SIB 12 01 21

RECALL 20V-761: CHECK 48 V CABLE CONNECTIONS ON STARTER GENERATOR (SGR)

This Service Information Bulletin (Revision 2) replaces SI B12 01 21 **dated February 2021**.

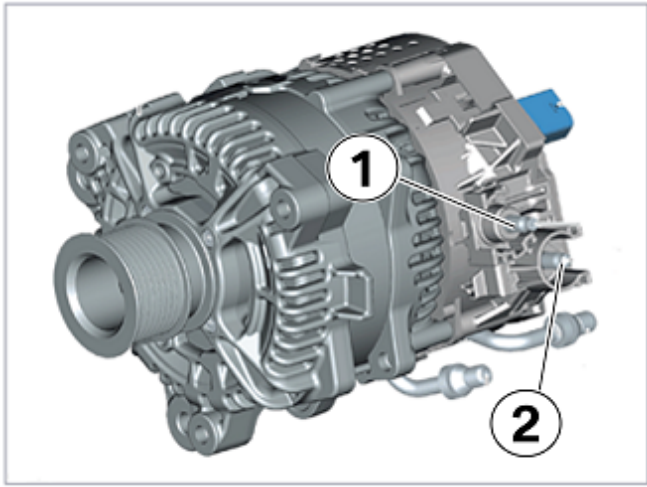
Check the positive (1) and negative (2) cables for play at the mounting lugs on the SGR.

If there is play in the connection to the SGR –

- Deactivate the 48 V electrical system (Repair instruction REP-TAT-P-6124-18-B47_48V)
- Remove and discard the flange nut on the B+ or B- cable
- Install a new flange nut so that it’s carefully started by hand to avoid cross-threading
- Torque to 19 Nm
